DESIGN ADVISORY BOARD Tuesday December 8, 2015 at 3:00 PM Conference Room 12, City Hall, Burlington, VT Agenda

MEMORANDUM

To: The Design Advisory Board
From: Mary O'Neil, AICP, Principal Planner
RE: ZP16-0622CA; 351 North Avenue
Date: December 8, 2015

File: ZP16-0622CA
Location: 351 North Avenue
Zone: WRM **Ward:** 4N
Date application accepted: November 17, 2015
Applicant/ Owner: Eric Farrell / E.F. Farrell, LLC
Request: Change roof material from slate to standing seam copper on former orphanage building.

1 EAST ELEVATION
Scale: 1" : 50'

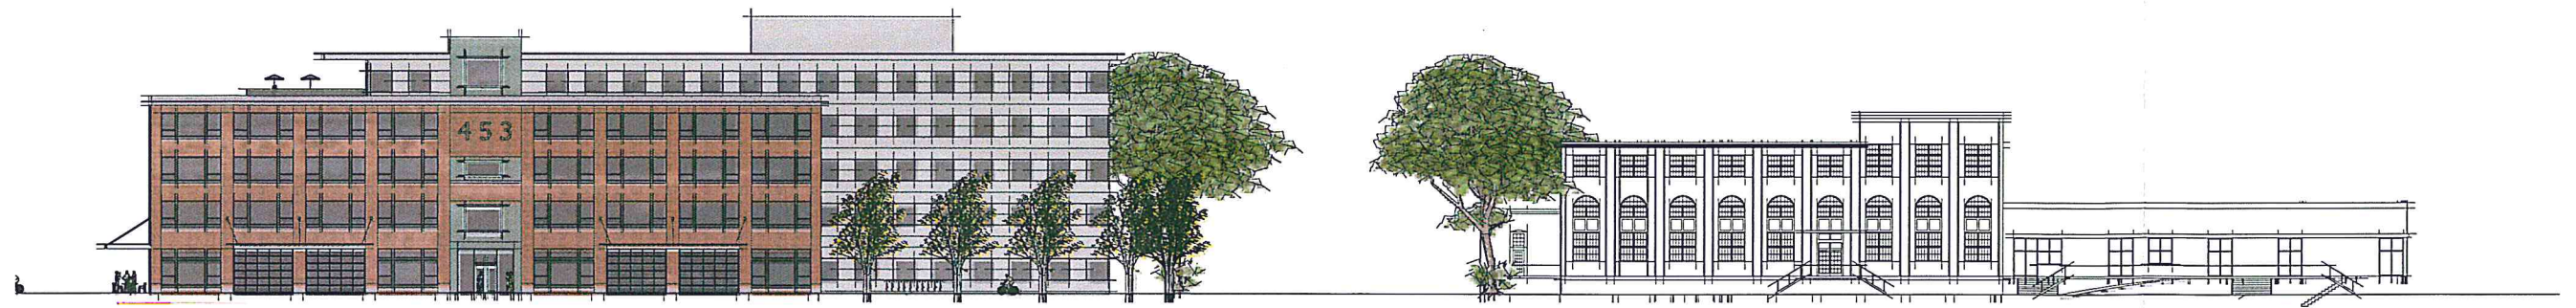
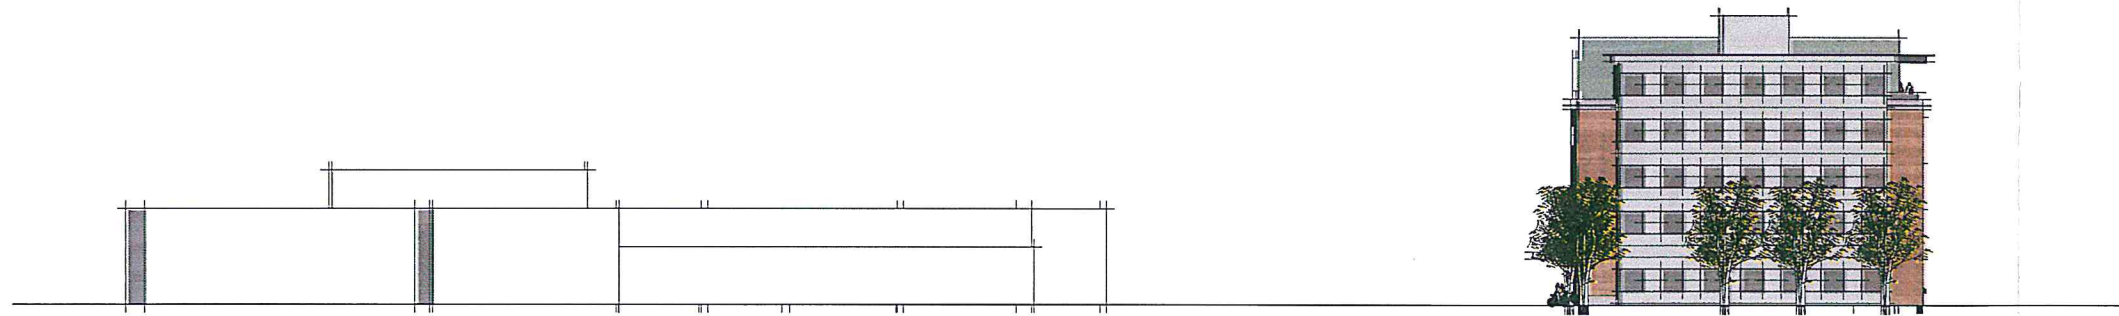
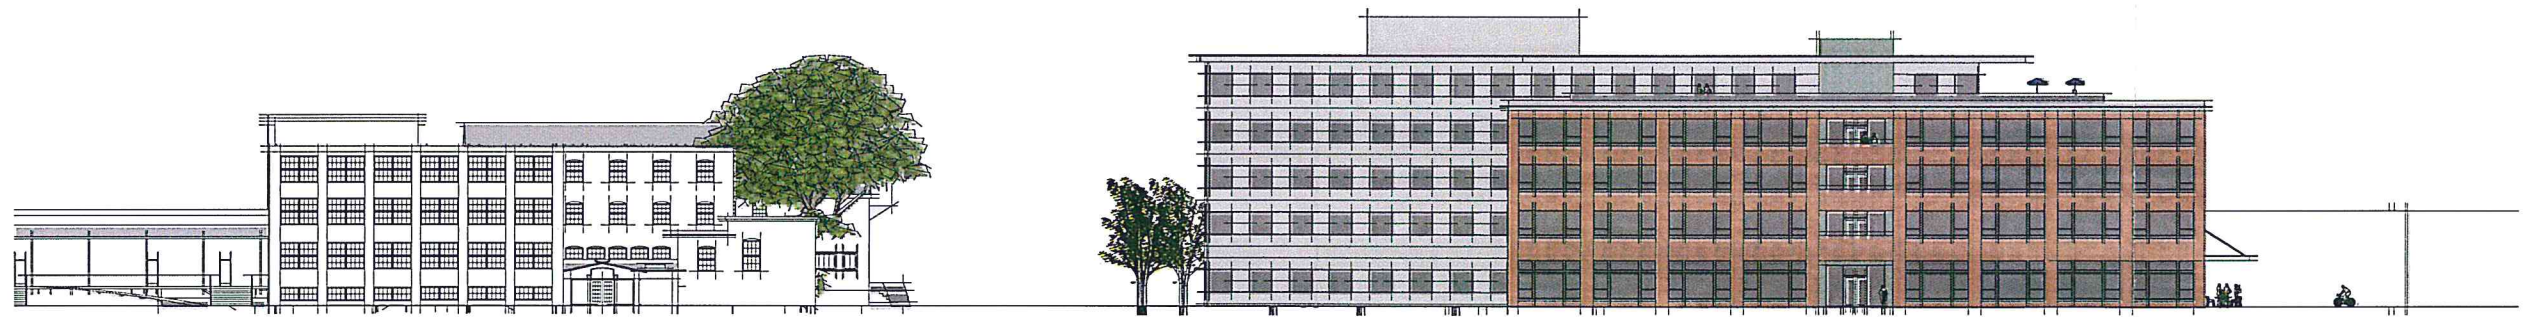
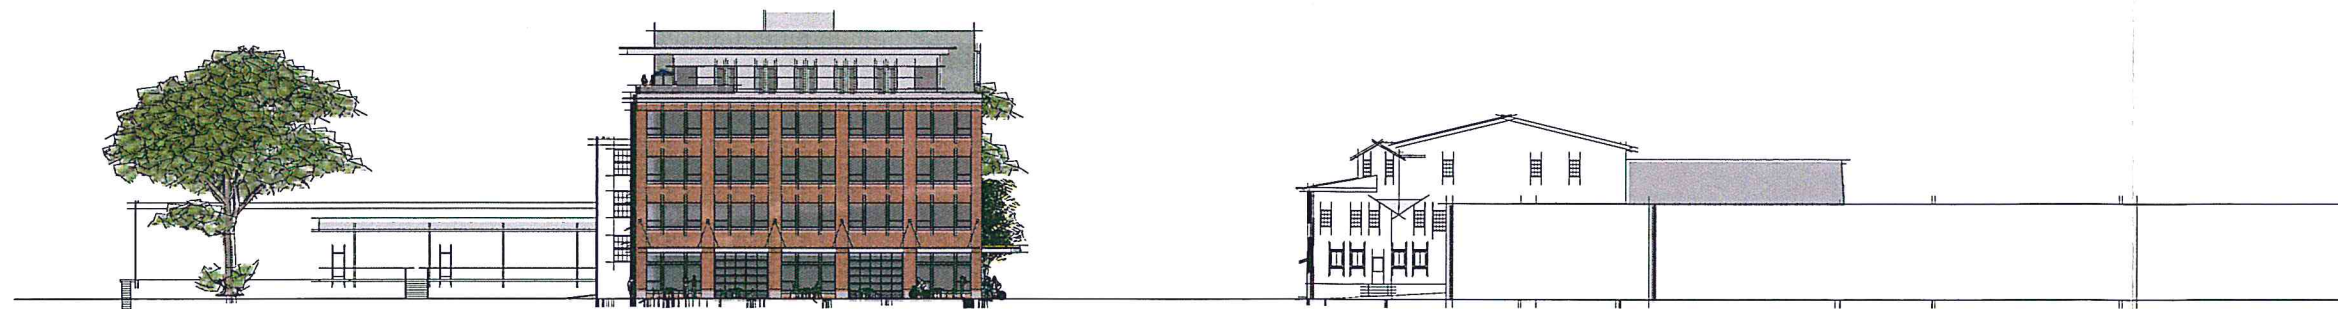
Exact building height is not specified, but at 5 stories, the proposed building presumably exceeds the 45’ height limit in the ELM zone and will be one of the taller structures in the South End. Though not articulated in the sketch plans, the applicant is expected to seek the increased height under Sec. 5.4.9, *Brownfield Remediation*. This provision allows waiver of standard dimensional requirements (including height) on brownfield properties. The idea is to allow for flexibility in building design to enable development on sites constrained by

The front building section provides the primary interface with the street. As noted above, it has a well-defined front entry linked to the public sidewalk. The street level is differentiated from upper levels with distinct fenestration. The front entry is sheltered by a projecting canopy, and storefront fenestration on either side is likewise accented by overhanging canopies. Ground level windows provide visual access into the building interior. Window mirroring or frosting is not noted and would not be permitted. The building/street interface is further strengthened by the front swath of hardscaping, sitting benches, and artwork.

The sketch plans note no building materials. The permit application must specify all exterior building materials.

While not specifically noted, the sketch plans appear to depict a rooftop mechanical enclosure and elevator penthouse. The permit application must specify these features and their materials and dimensions.
